An Coimisiún Pleanála - Case reference: PAX92.324279

Observation on Proposed Wind farm and related works within the townlands of Cloonaheen, Ballincor Demesne, and Curralanty, Co. Offaly, and Clonfree, Castletown and Cronekill, Co. Tipperary.

Greater Birr Wind Action Group Submission

Figure 3.3 Flood Plain and proposed Infrastructure

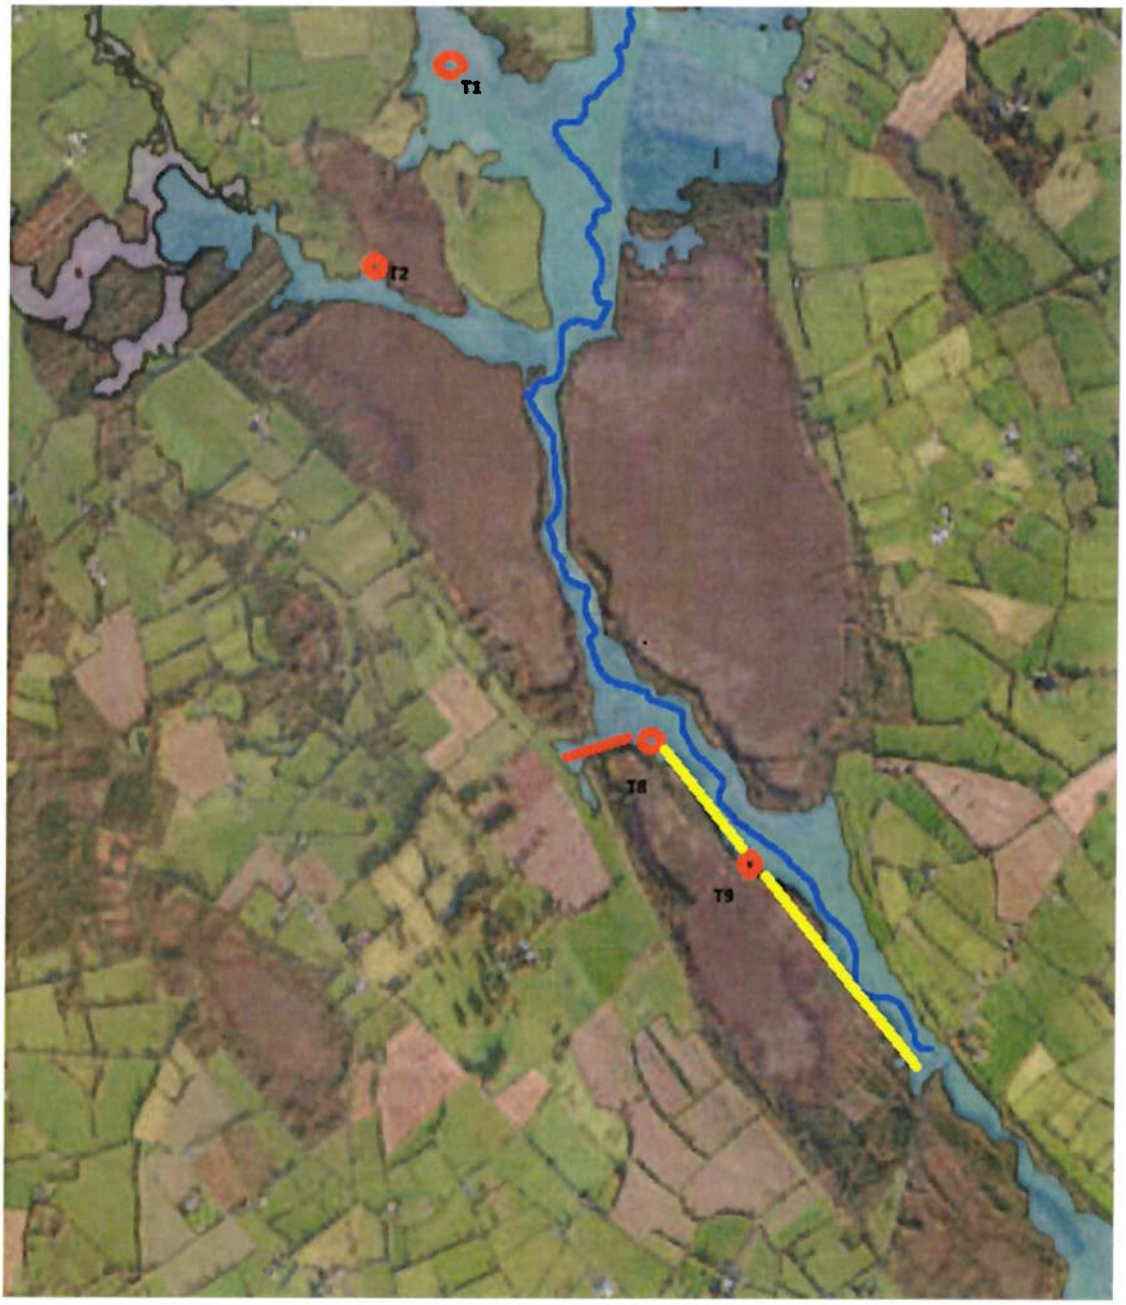
Figure 3.3 below shows the access tracks, and T1,T8, T9 in the flood plain and T2 in very close proximity in regular flooding activity

Figure 3.4 Sharavogue Bog – River is Boundary

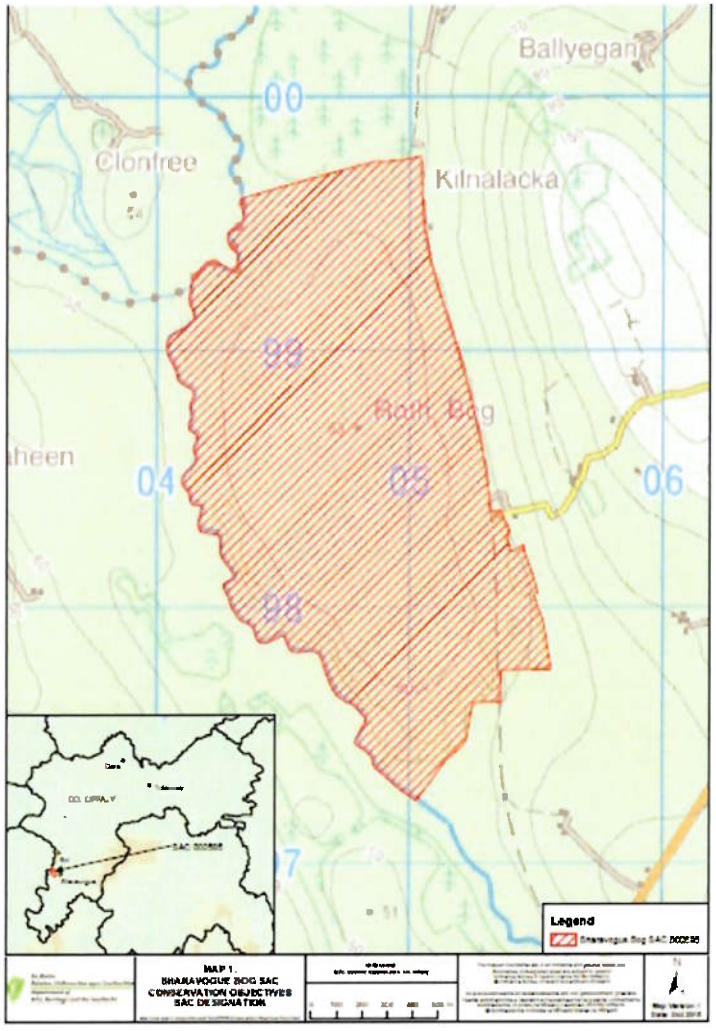
Figure 3.4 below shows the relationship between Sharavogue Bog SAC (site code 000585) and the River Brosna. Sharavogue Bog sits immediately east of the wind farm site, with its western boundary defined by the River Little Brosna — the same watercourse that forms the eastern boundary of the development. As previously shown the Proposed development site will use the river as its eastern boundary so a direct overlap is presented. The SAC boundary is classified in the Applicants documents as less than 10 metres from the wind farm perimeter at its closest point, adjacent to T8 and T9.

Figure 3.6 Tributary Network on the Proposed Site

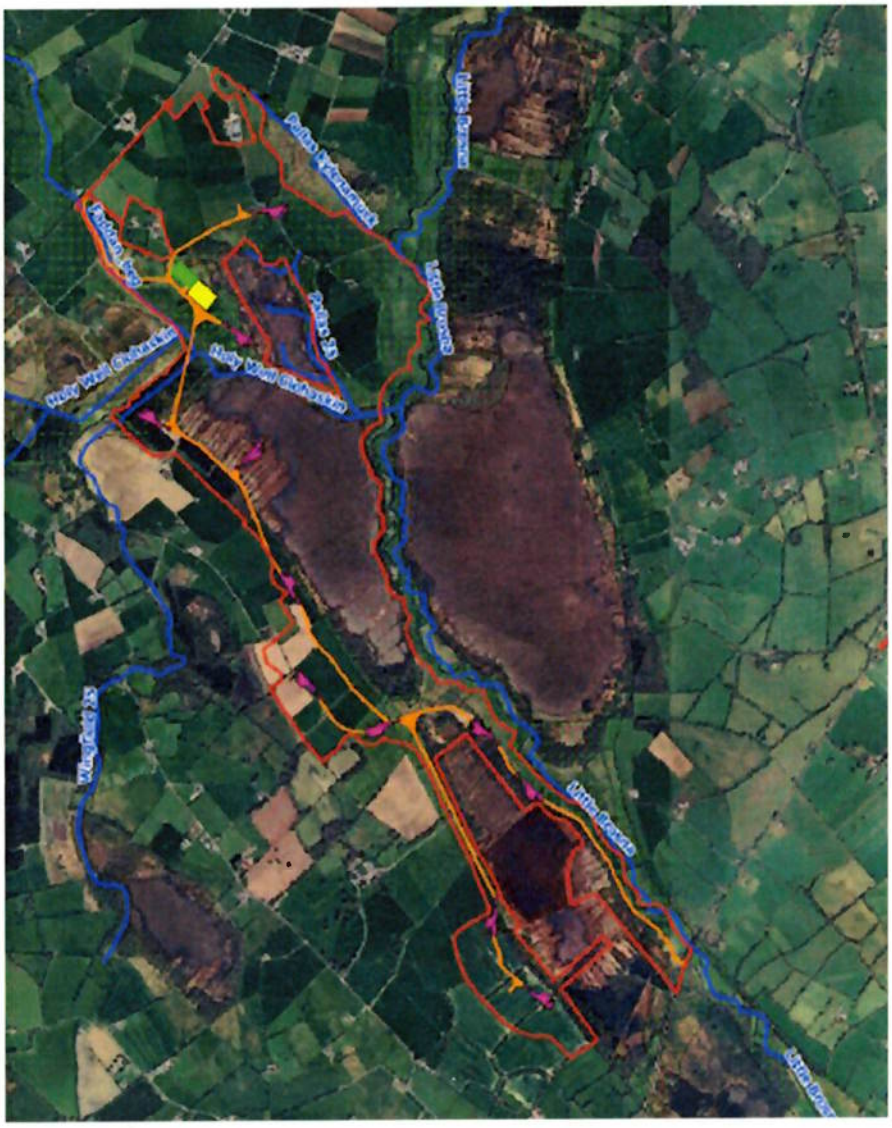
stream, a first-order watercourse, traverses the northeast of the site before discharging to the Little Brosna approximately 25 metres downstream of the survey point (Appendix 9-1, p.7). Fourteen internal drain crossings are proposed, mostly peat drains, along with a crossing of the Holy Well Clohaskin River between T2 and T3.

Figure 3.7 Soil Survey Map (RWE application)

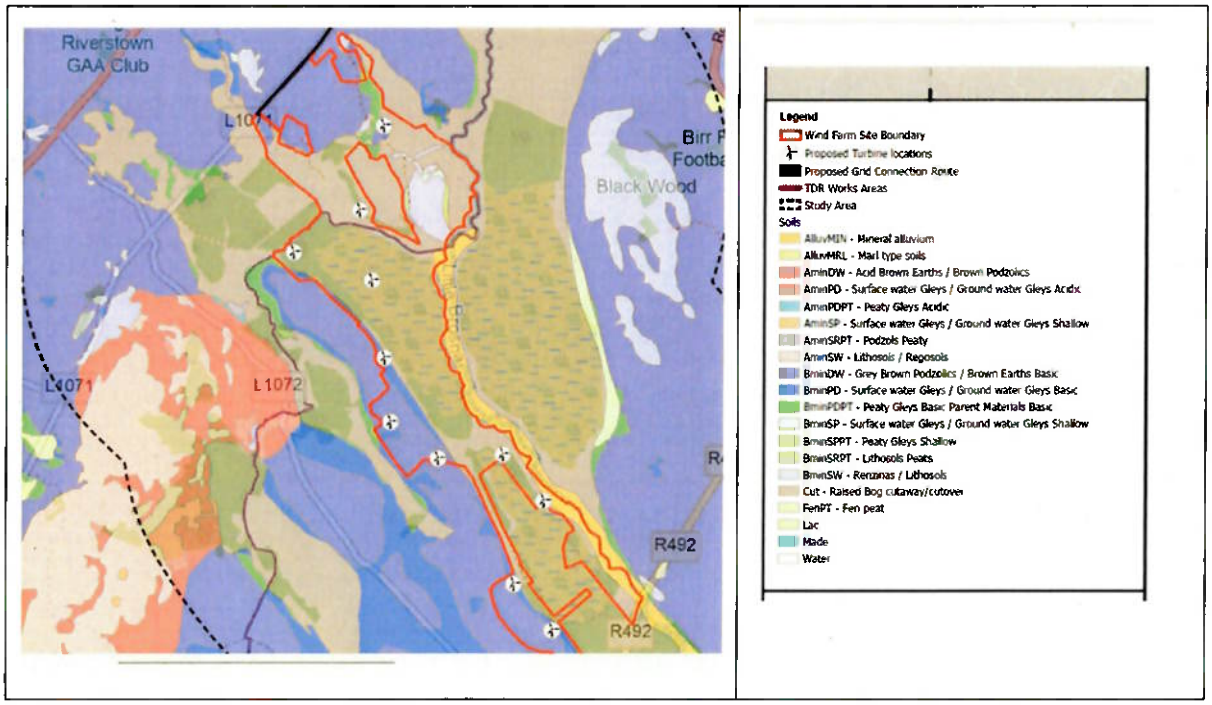
SI soil survey mapping presented above shows a continuous belt of AlluvMIN (mineral alluvium) flanking the Little Brosna corridor — an extensive active and historic floodplain with direct river connectivity. Source: FRA App.9-3, pp.11–15; OPW floodinfo.ie; GSI Soils Map

Figure 3.16: Trial Pits/Boreholes from RWE Application

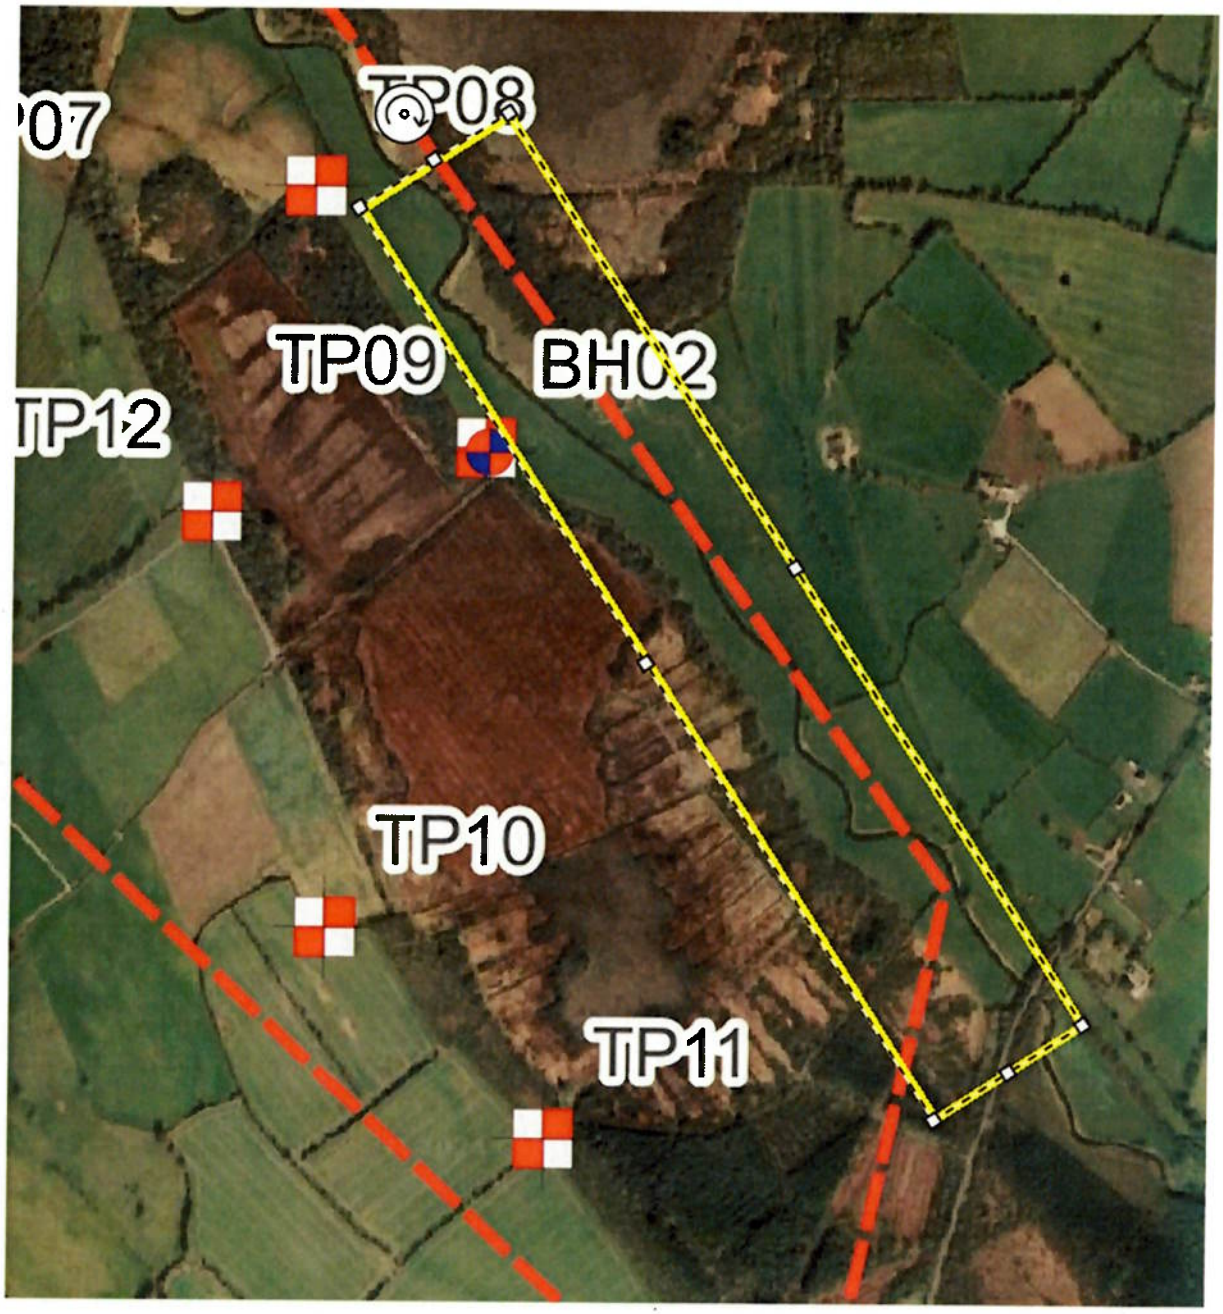
The ground investigation comprised 23 trial pits and 3 boreholes across the entire site. In the T8/T9 zone — the valley floor in Flood Zone A/B, closest to the river and the SAC — the investigation points are TP08, TP09 and BH02. All three are located at or near the turbine hardstand positions. See Figure 3.14 below. Not one trial pit or borehole was positioned along the access track alignment in this corridor. Peat probes in this area were located at turbine positions only. The claim that ground investigation has informed track design in this zone is not supported by the ground investigation data submitted.

This matters because the peat depth map (EIAR Figure 8-6, Appendix 8-2 PSRA page 40) shows the deepest peat on the site concentrated in precisely this corridor — 2.1–3.9m depths clustered around T4, T8 and T9 (EIAR Ch.8, p.8-22). The zone with the deepest peat, the highest flood risk and the greatest proximity to the river and SAC is the zone with the least investigation along the route where tracks will actually be built.

Figure 3.17: Sharavogue Bog Hydrological Connectivity

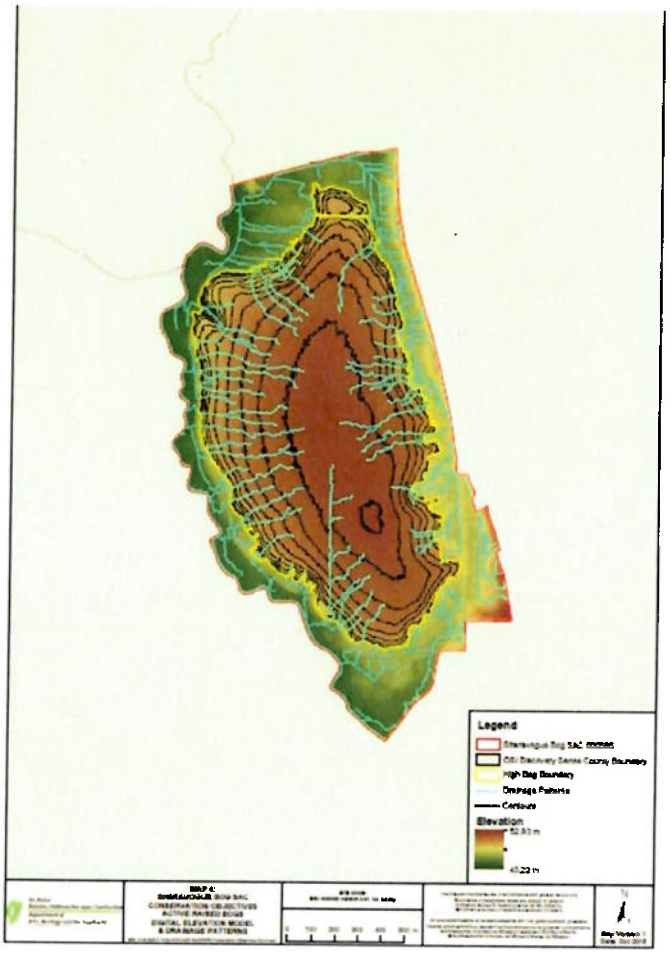
NIS Table 6-1 (p.118) explicitly identifies hydrological connectivity to Sharavogue Bog SAC via the Little Brosna_040 and drainage ditches and records a groundwater pathway via the Shinrone groundwater body to a SAC designated for groundwater-dependent habitats: "a potential for adverse effect was therefore identified." This conclusion is strongly supported by the image below.

No mitigation measure, engineering control, or changed hydrogeological assumption bridges these two conclusions. The groundwater pathway identified in Table 6-1 disappears in Table 6-2 without explanation. This is the lacuna that CJEU C-461/17 (*Holohan*, 2018, para.44) prohibits: an Appropriate Assessment must contain complete, precise and definitive findings free of gaps. The independent review reaches the same conclusion, identifying the source–pathway–receptor chain as established and the information before the Commission as contradictory (Hydro-G Report, Appendix 3-1, S4.2).

Figure 8-24: *ZTV Map View of 9-11 Turbines*

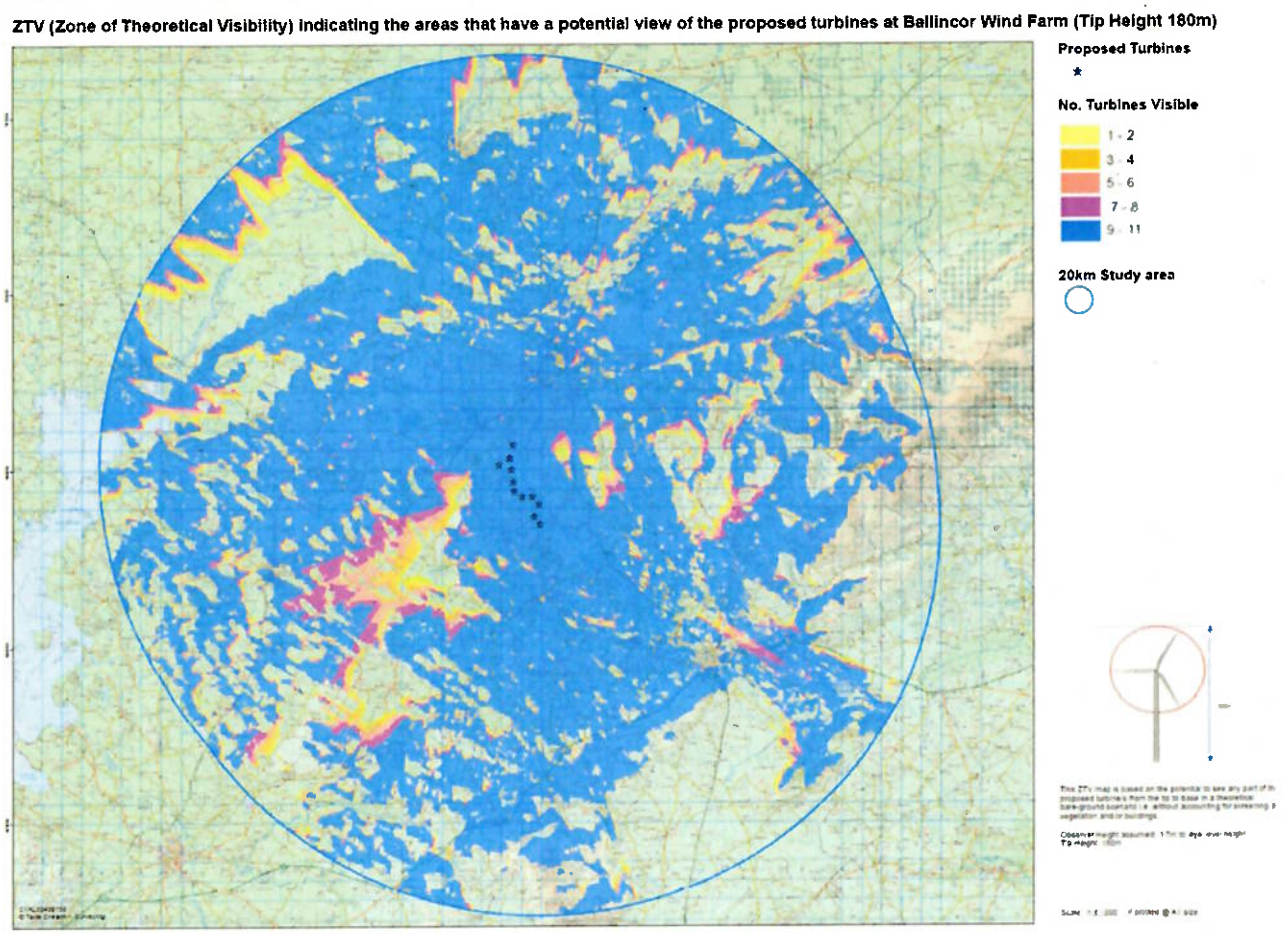
The Applicants ZTV maps below corroborate this position. The blue area illustrates those areas that have a potential view of 9-11 turbines in the 20km study area

Figure 8-34. *Applicants VP11 taken from 12.5km -turbines hardly visible against the blue sky & haze in the distance*

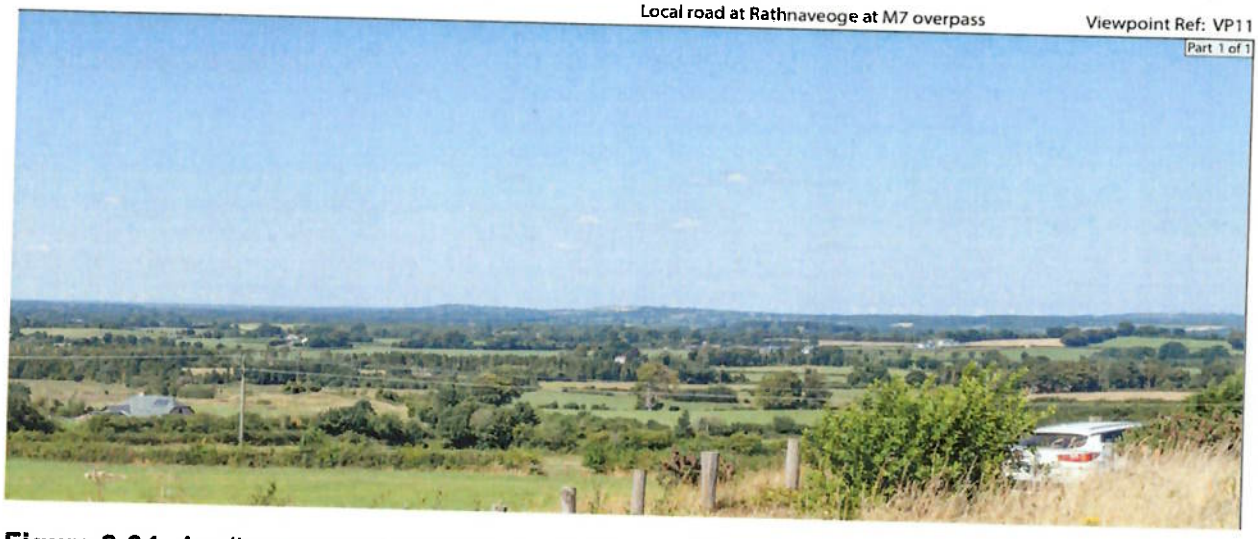
The images below taken from Applicants Photomontage show how visual effects can impact the reality and how atmospheric conditions will screen out the visibility of Turbines (blue sky and hazy background). Compare Figure 8-34 and Figure 8-35.

Figure 8-40 *VP26 Image representing Birr town: taken a few meters from mature trees beside Birr Castle Demesne*

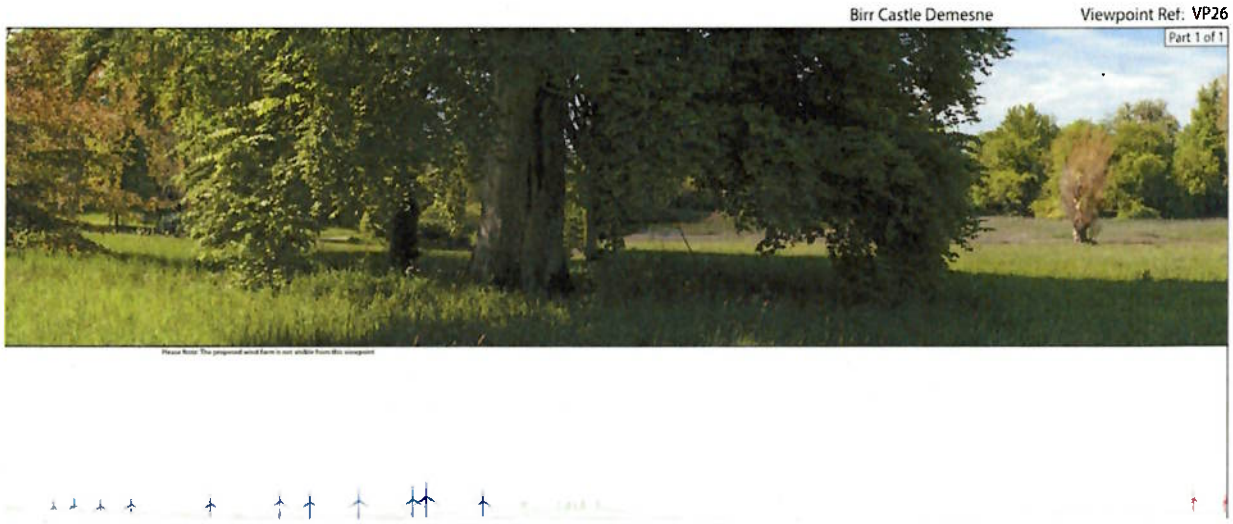
8.9.5.2 Birr is effectively unassessed. A town of approximately 5,000 people lies 4–5 km north of the site, on rising ground overlooking it. The town's representation in the viewpoint set consists of VP6 at Birr Rugby Club (5.3 km, on the town's southern edge) and VP26 within Birr Castle Demesne (5.4 km, an enclosed parkland setting where screening is at its maximum). No viewpoint addresses the residential areas, approaches or elevated southern aspect of the town itself. The result is that the largest single concentration of visual receptors in the study area is represented by a rugby pitch and a walled demesne.

Figure 8-44: *Cumulative theoretical visibility of the proposed Ballincor Wind Farm in combination with all other wind farms in the study area*

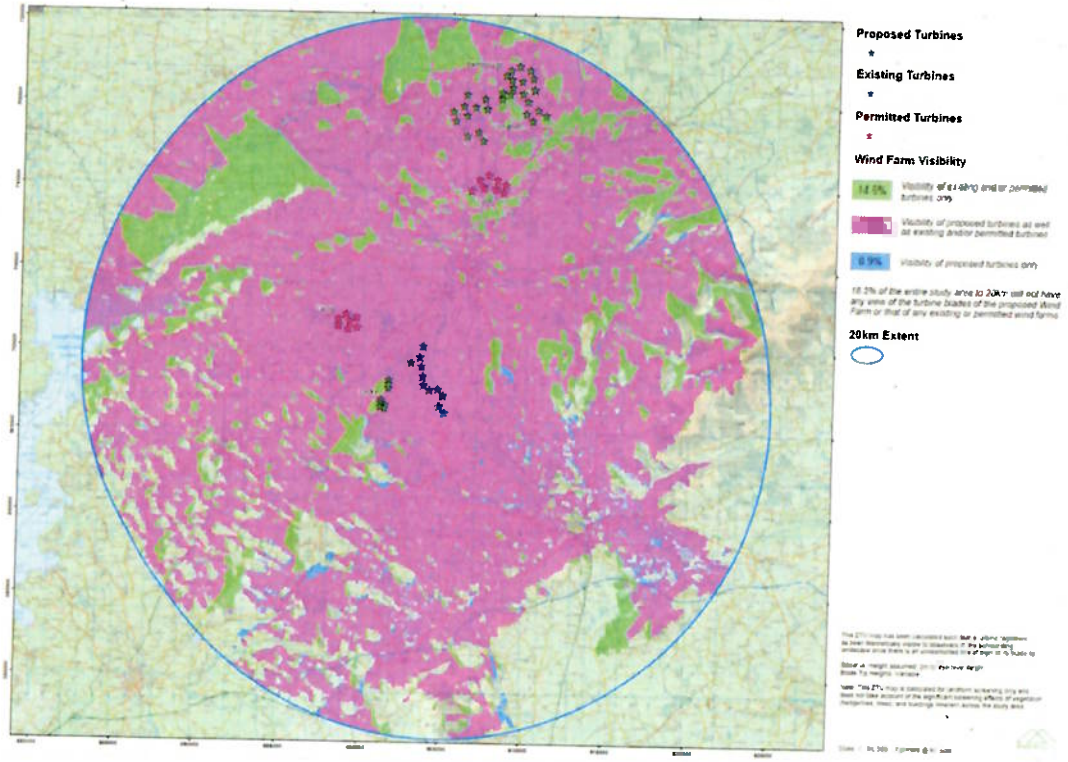
Section 12.7 of the chapter disposes of cumulative effects in summary terms. It acknowledges the operational Lacka Wind Farm, describes the proposed (Ballincor) and existing (Lacka, Carrig) developments together as " *modest scale developments*" that "*do not contribute to a marked change in landscape character*," and concludes that the area "*will not become a landscape that is defined by wind energy development*." It produces a cumulative ZTV (Figure 12.12) see below, notes that it shows near-universal overlap of visibility between the proposed and existing developments and then discounts its own map as one that "*considerably overrepresents actual cumulative effects*."
